CITY OF MERCER ISLAND

Pre-Application Meeting (PRE20-038)

Site Location:	9820 SE	35 th PL			
Lot Size:	21,700s	f	Zoning:	R-9.6 (Single Family)	
Brief Project Description:		ddition of heated space and a ed 2 car garage.	Documents Provided:		
Applicant Infor	mation:				
Name: Priscilla Wenzel		Phone: priscilla@mediciarchitects.com 602-568-5689			
Second Pre-application Meeting Required: Not Applicable Click for explanation if necessary

WOODSON LOT LINE REVISION FILE NO. MI 920781

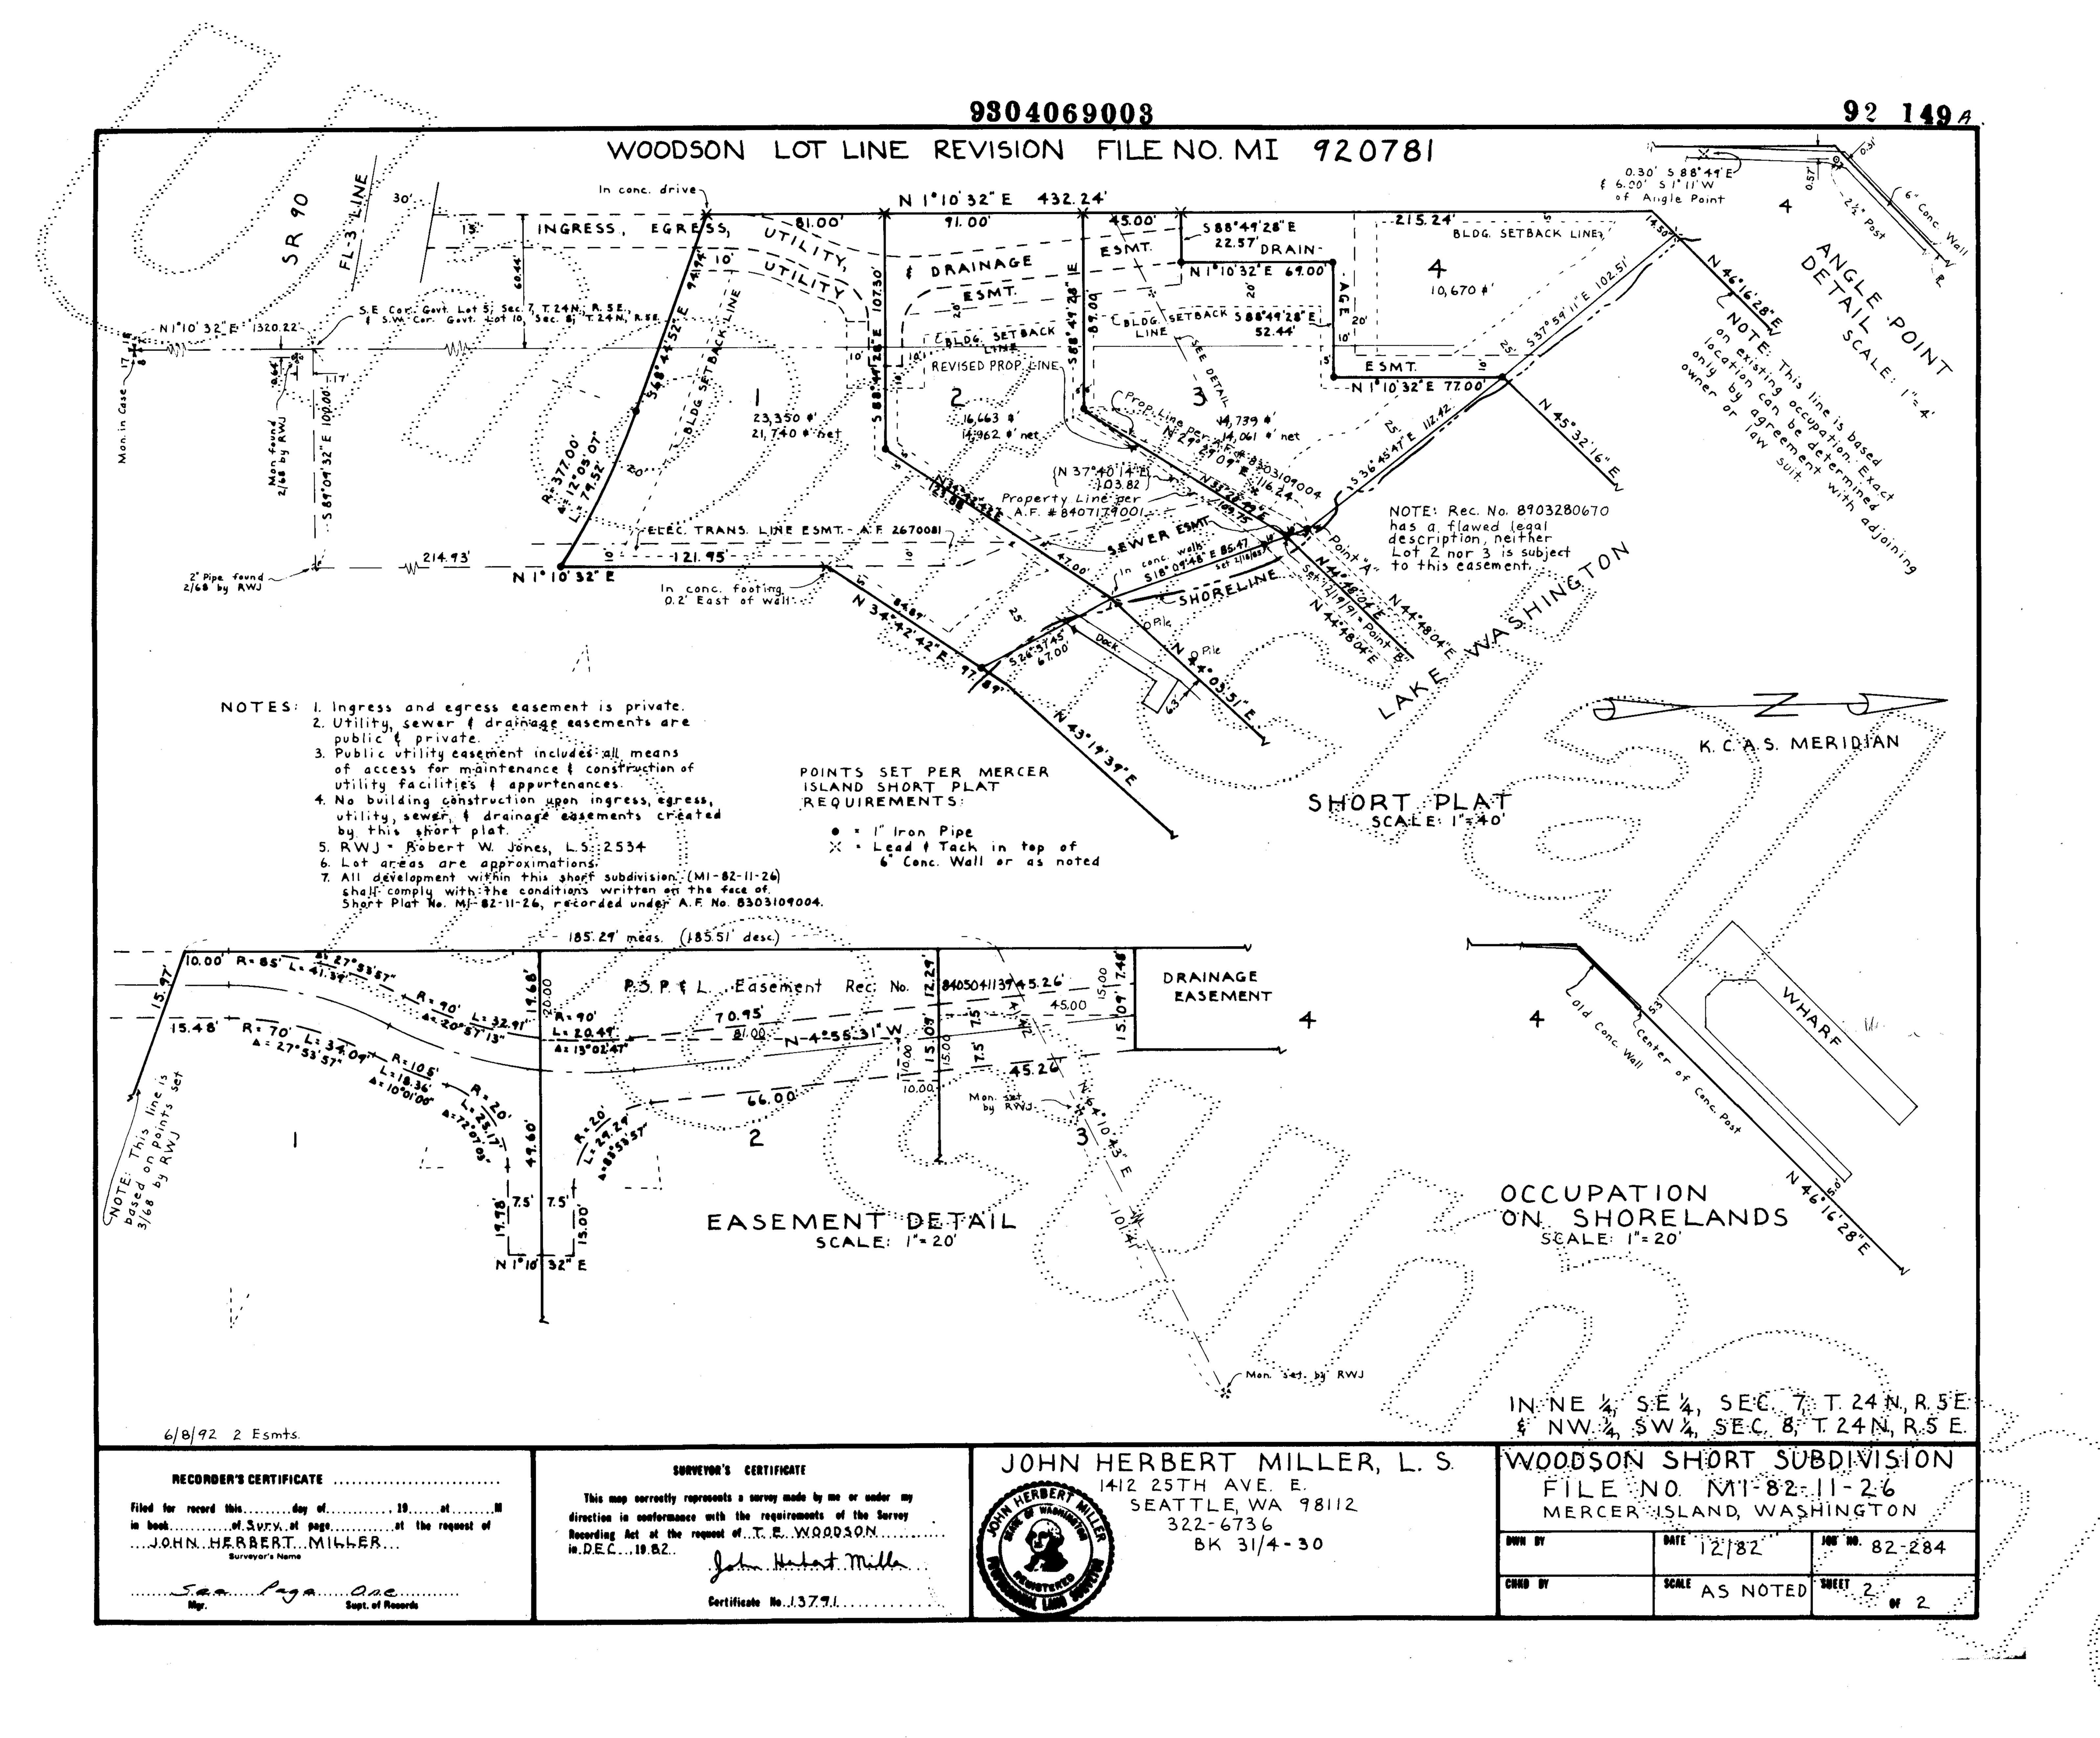
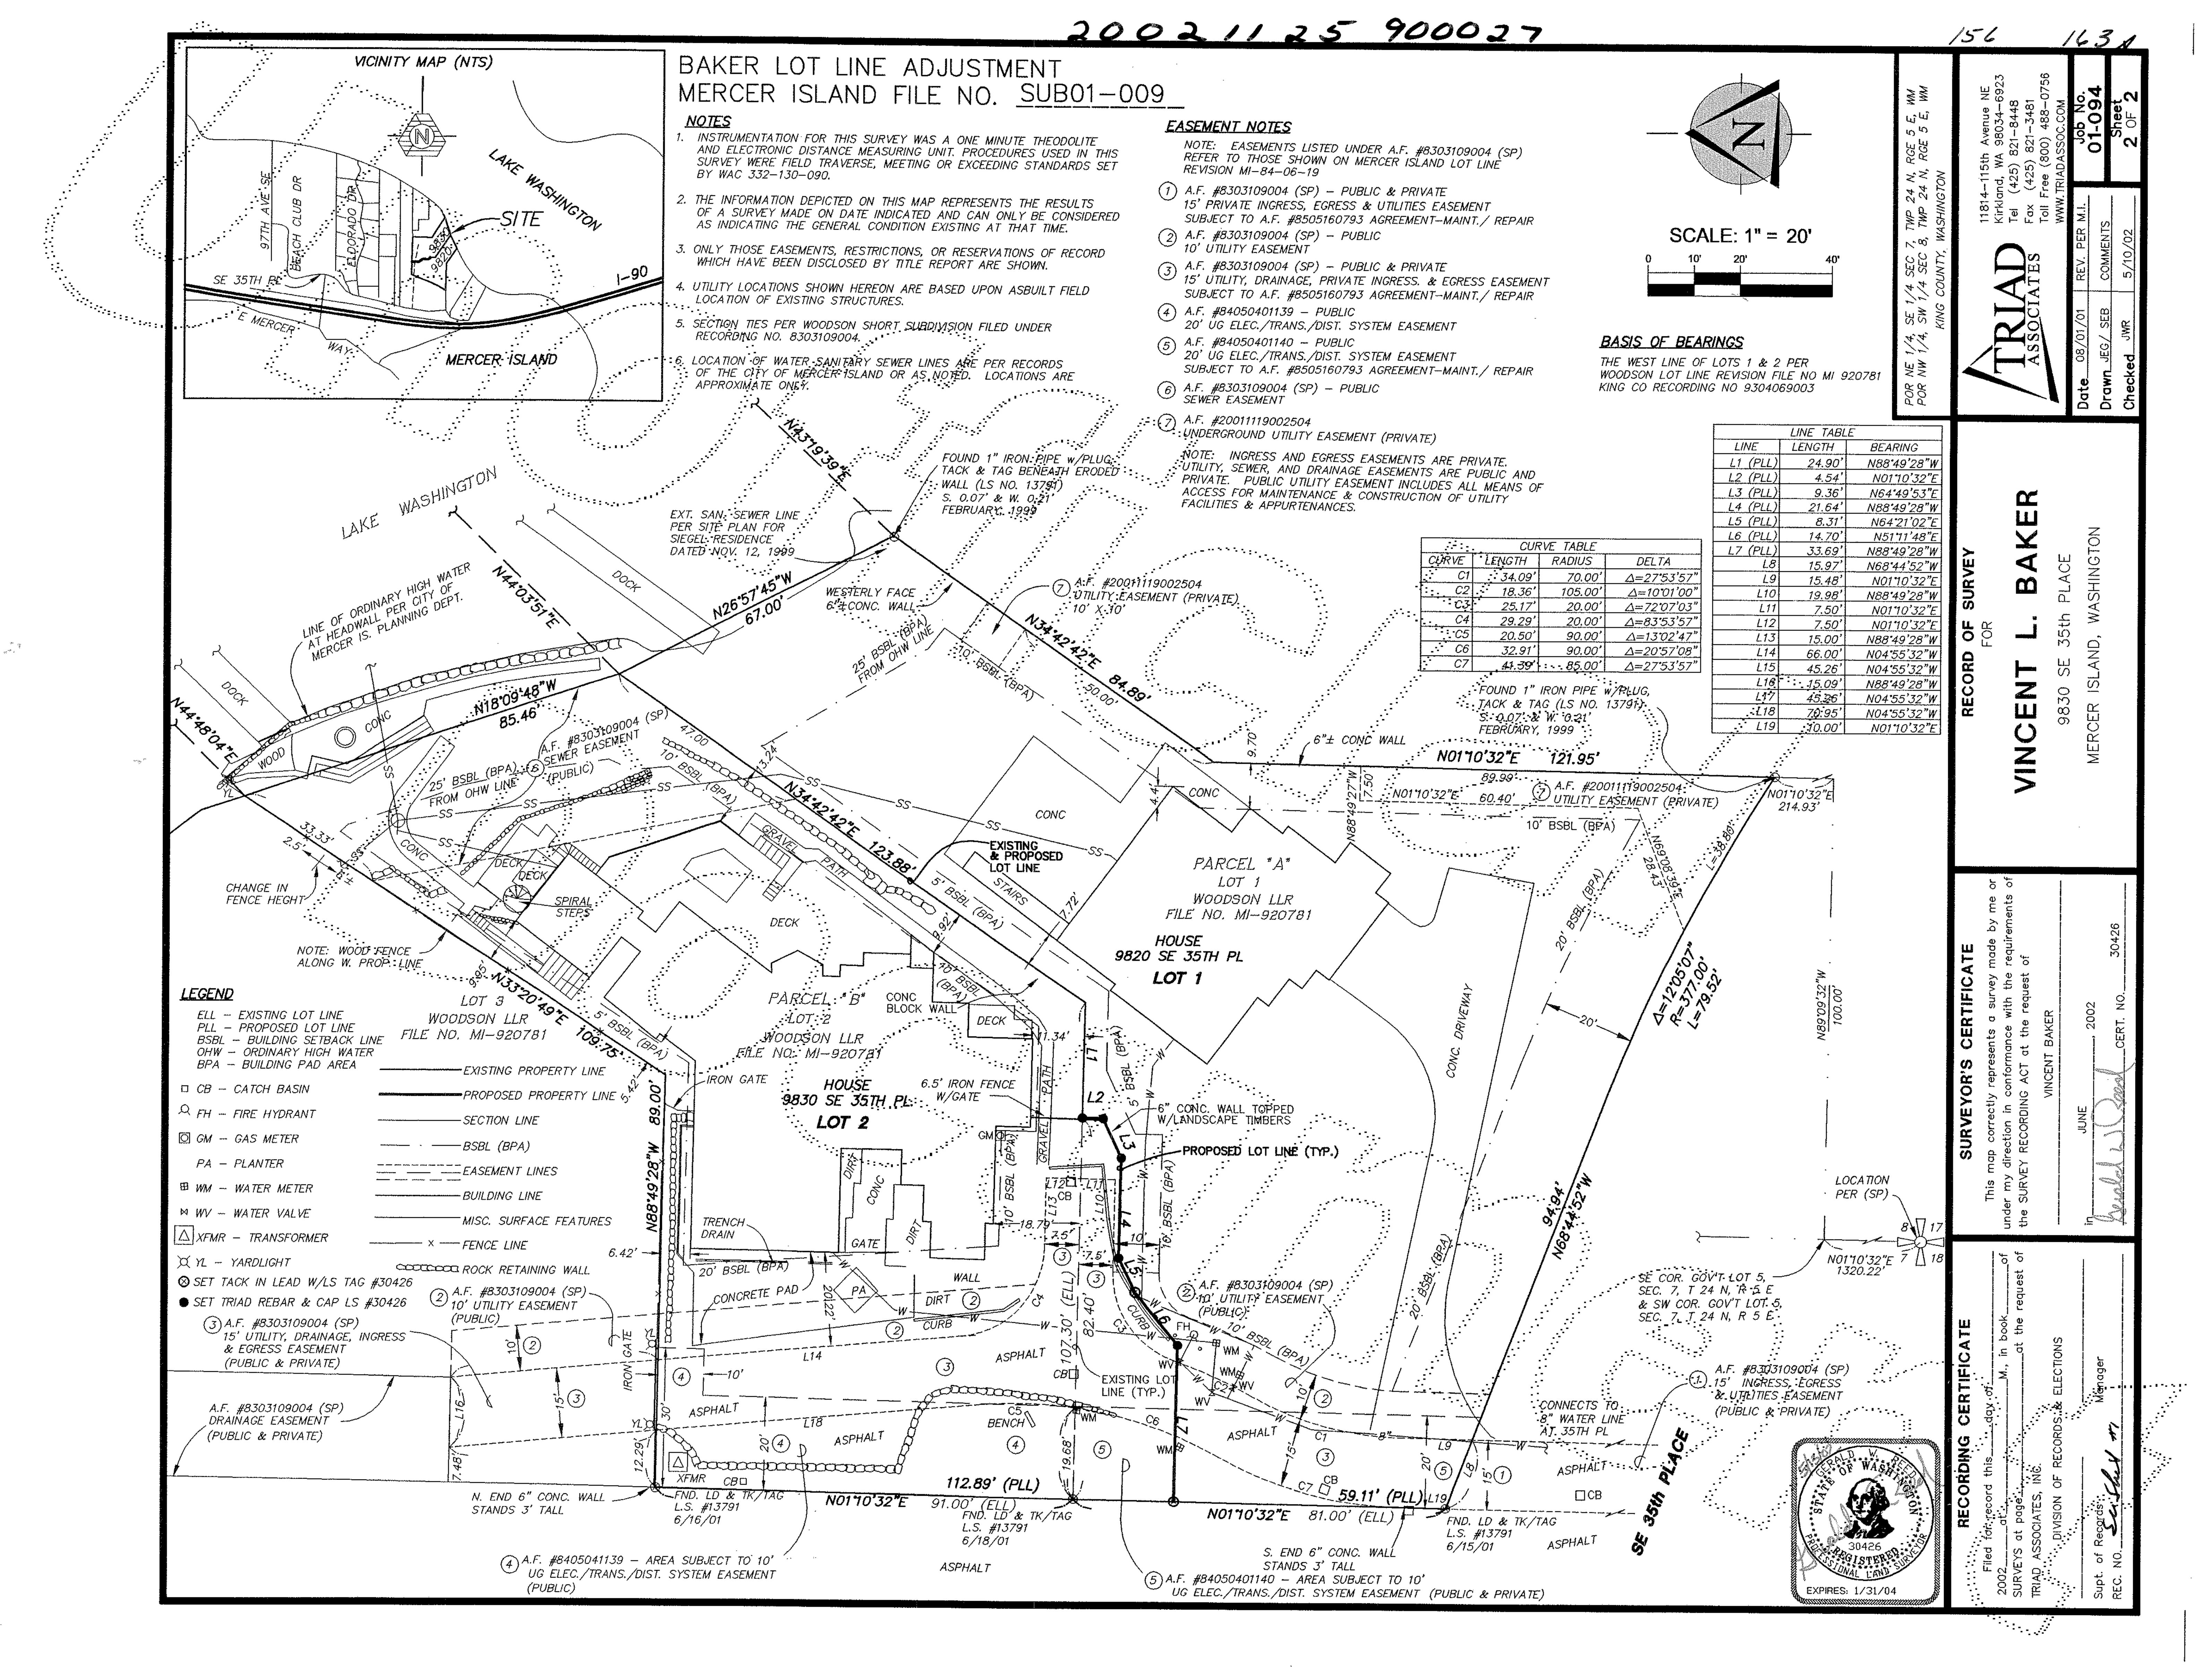
- a. Lauren Anderson (Planning) response: the recorded setbacks on the plat do vest. There was a lot line revision in 1993 under SUB9206-014 – please refer to Attachment 1. In 2001 there was the Baker lot line revision under SUB01-009, Recording #20021125900027 – refer to Attachment 2.

b. The setbacks that were recorded on the latest subdivision is what the project vests to – thus the side yard setbacks are 10 feet to the south and 5 feet to the north that then becomes 10 feet for the northwest portion – refer to Attachment 2. Please refer to the snippet below:
